Lease No. 14-20-605-2034
Co. Loc. No. 234871

SUNDRY NOTICES AND REPORTS ON WELLS

Chimney Rock (Gallup)

Company Hamble Oil & Refining Company

Well Location and Acreage Dedication Plat

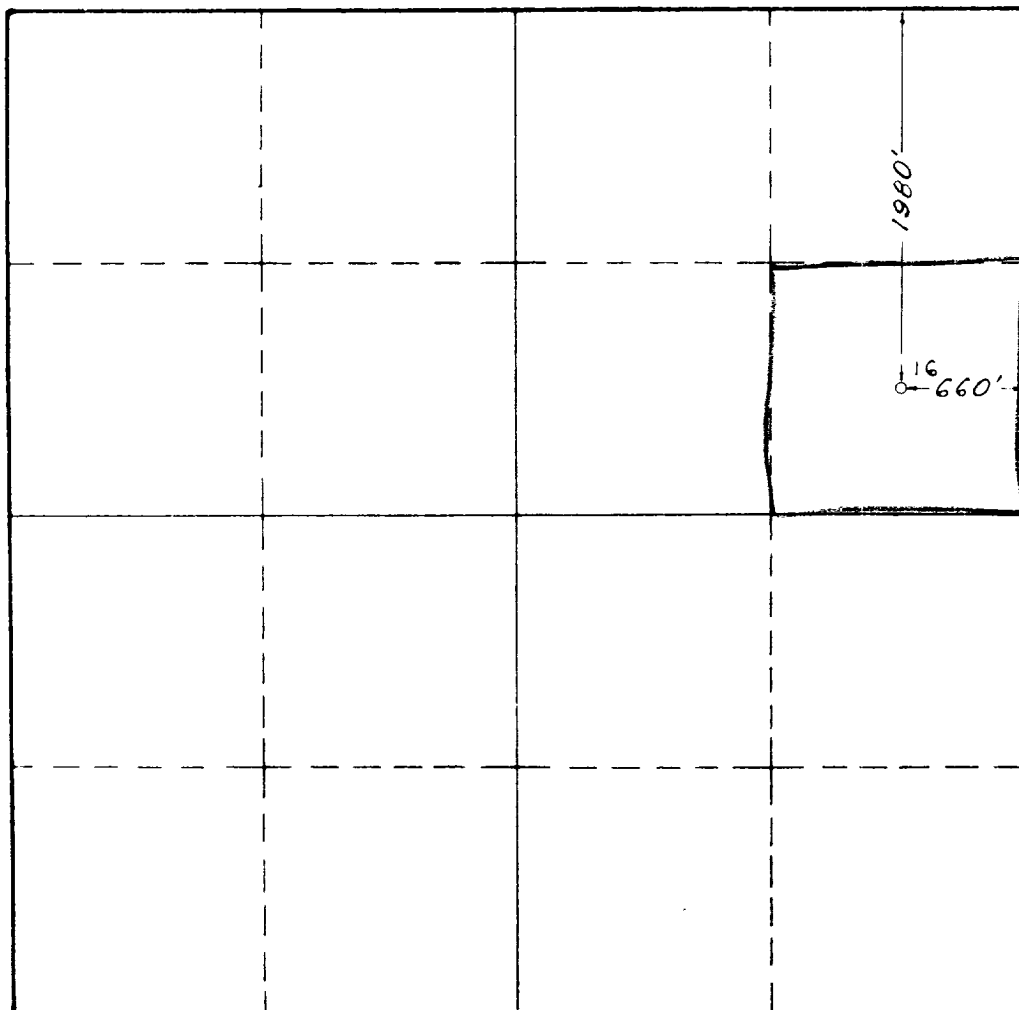
Note: Amended form filed to change location from 1900' from South line & 2000' from East line of Sec. 10, T-31-N, R-17-W, due to location being located too high structurally and would result in a gas well.

Operator HUMBLE OIL & REFG. CO Lease Navajo Tribe of Indians "F"
Well No. 16 Unit Letter "H" Section 10 Township 31-N Range 17-W NMFM
Located 1980 Feet From north Line, 660 Feet From east Line
County San Juan G. L. Elevation _____ Dedicated Acreage 40 Acres
Name of Producing Formation Gallup Sand Pool Chimney Rock
